**Rezoning Transportation Analysis**  
**Petition Number: Insert Zoning Petition #2021-213**  
*General Location Identifier: 22706130*

**Revision Log:**

Date	Revision Log:
01/21/2022	First Review (WB)

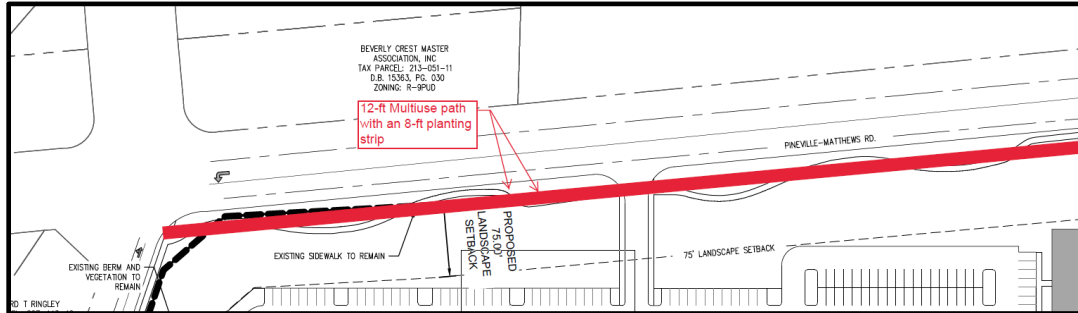
5. Site plan and conditional notes revisions are needed to commit to construct bicycle facilities by installing a 12-foot multi-use path along the site's entire Pineville-Matthews Road frontage in accordance with the Charlotte BIKES Policy.

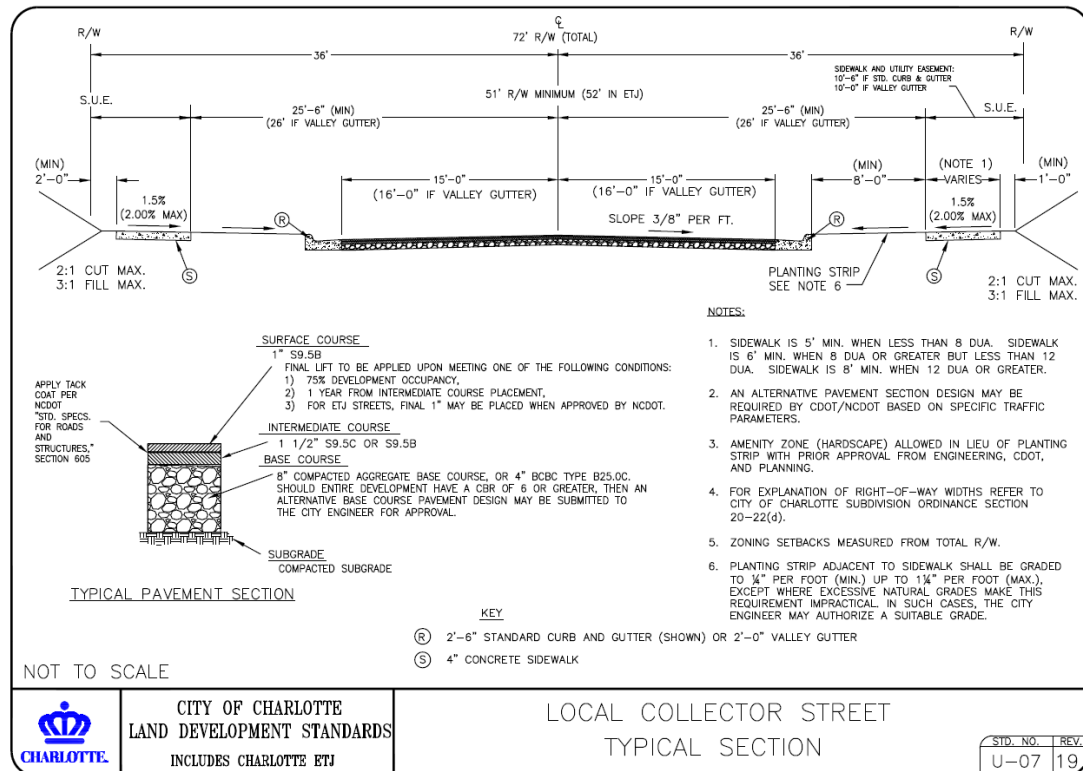
6. The proposed dwelling units exceeds 12 per acre. Per Chapter 20 Subdivision ordinance, site plan and conditional note revisions are needed to commit to construct an 8-foot sidewalk with an 8-foot planting strip along Hugh Forest Road. The wider sidewalk also meets the Charlotte WALKS Policy.

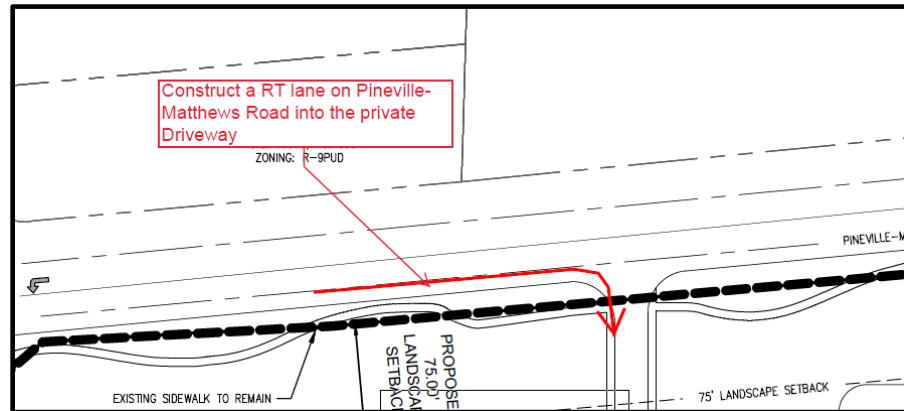
7. Revise site plan and conditional notes to commit to constructing a right turn lane on Pineville-Matthews Road into the proposed driveway per NCDOT standards.

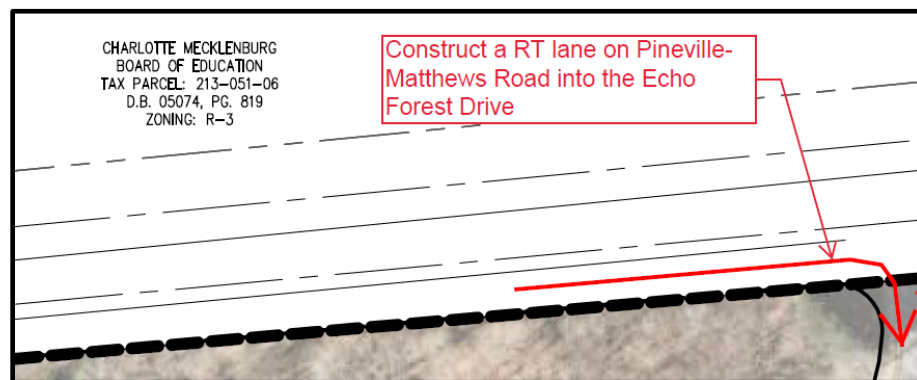
8. Revise site plan and conditional notes to commit to constructing a right turn lane on Pineville-Matthews Road into the Echo Forest Drive per NCDOT standards.

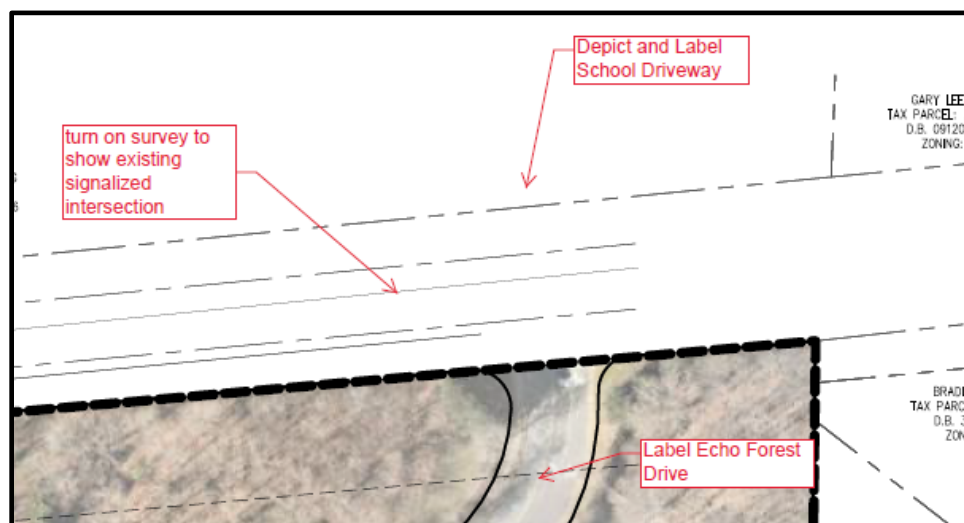
9. Revise site plan to adequately depict and label existing facilities, including the Echo Forest Drive, the signalized intersection at Echo Forest Drive, and the existing School Driveway.

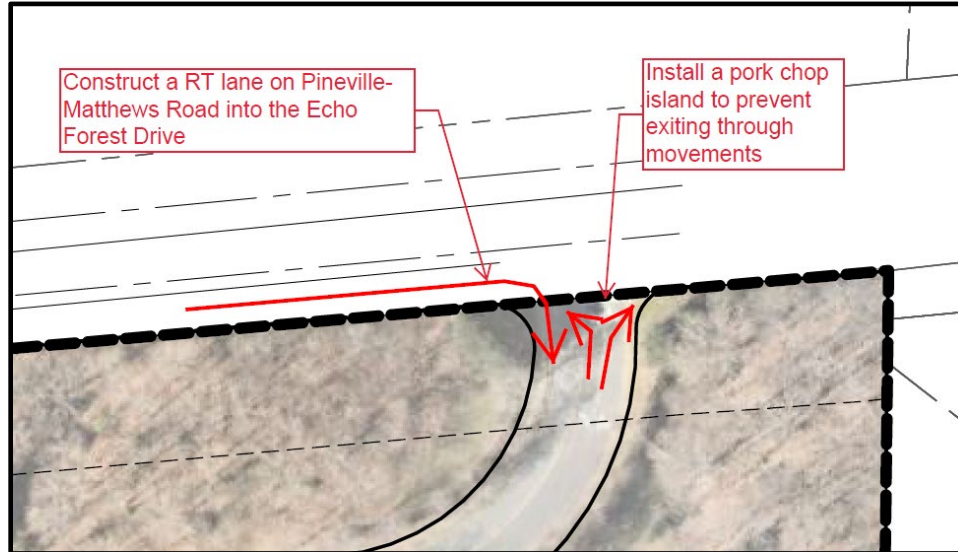
10. The egress movement at Echo Forest Drive shall be limited to 'left out and right out' only to mitigate the increase in traffic at the existing signalized intersection. No northbound through movements will be encouraged. Petitioner to install a concrete channelization island per NCDOT standards to enforce the restricted movement.

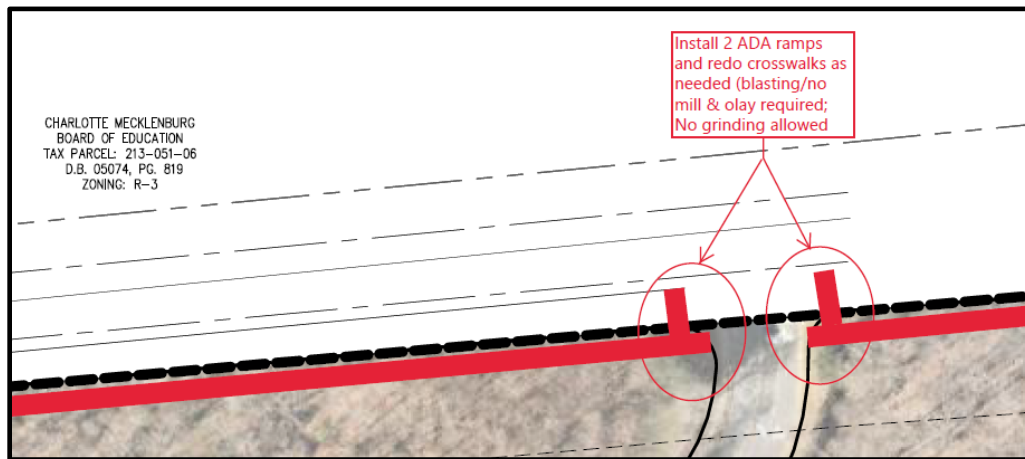
11. Site plan and conditional note revisions are needed to include the construction of two ADA Curb ramps on each corner of the Echo Forest Drive intersection on the south side of Pineville-Matthews Road per PROWAG and ADA law. Petitioner to coordinate with CIP Project on the construction of ADA facilities.
